Addendum-01

Project: Box Elder County New Arena Grandstands Tremonton UT

Date: 11-27-2018

Sheet Title: Sections & Details	
Project No: #2018-08	Date: 29 Oct 18
Scale: AS NOTED	
A3.1

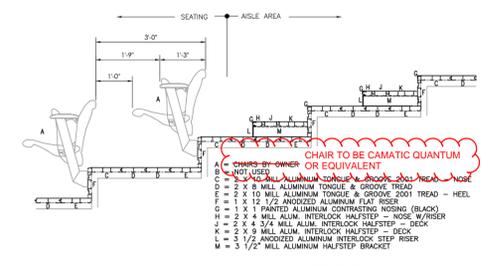
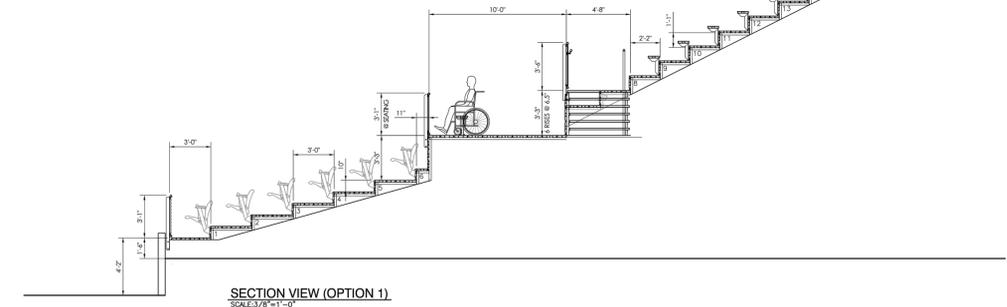
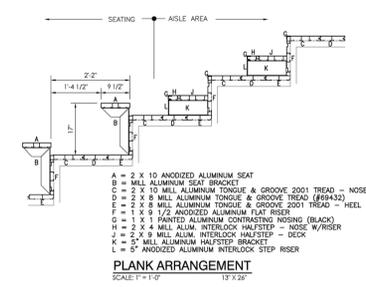
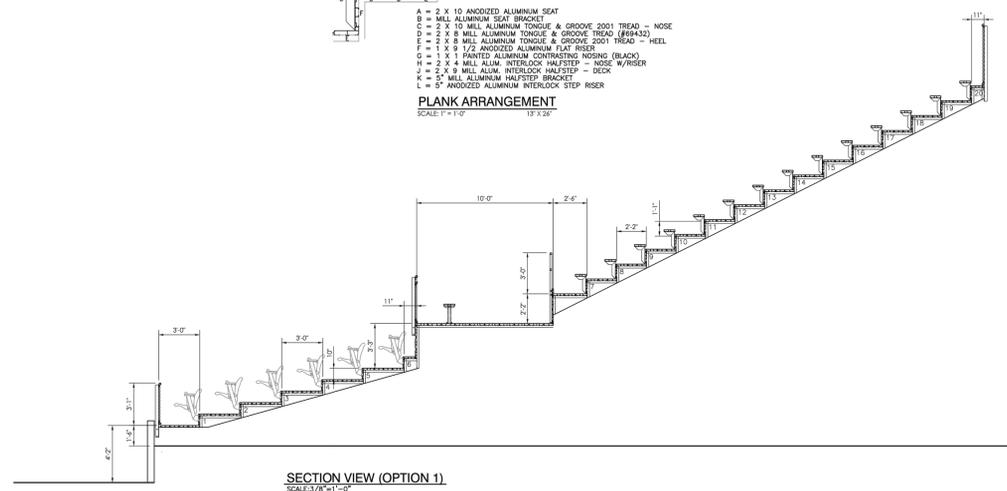
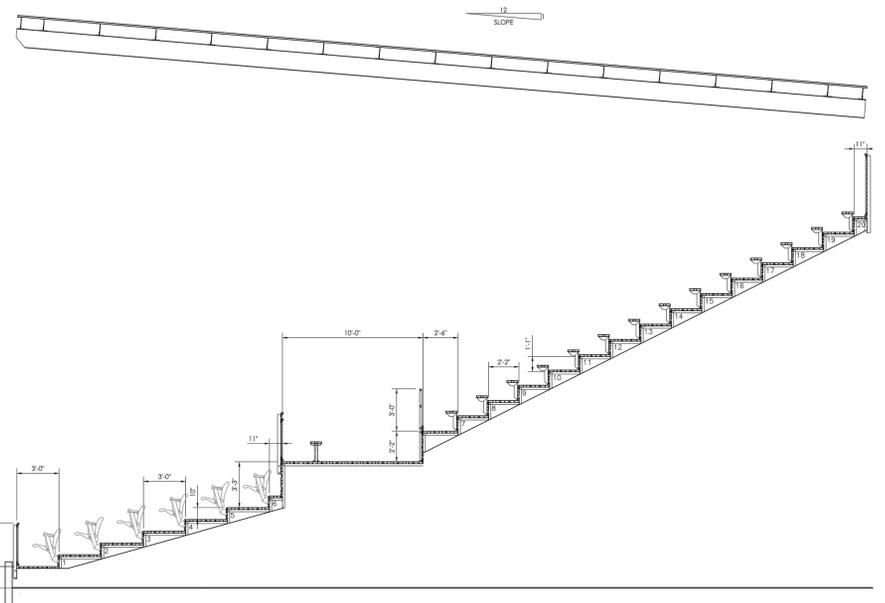
8. *Refer to attached revised sheet A3.1, which shows the revised conceptual sections for the project.*
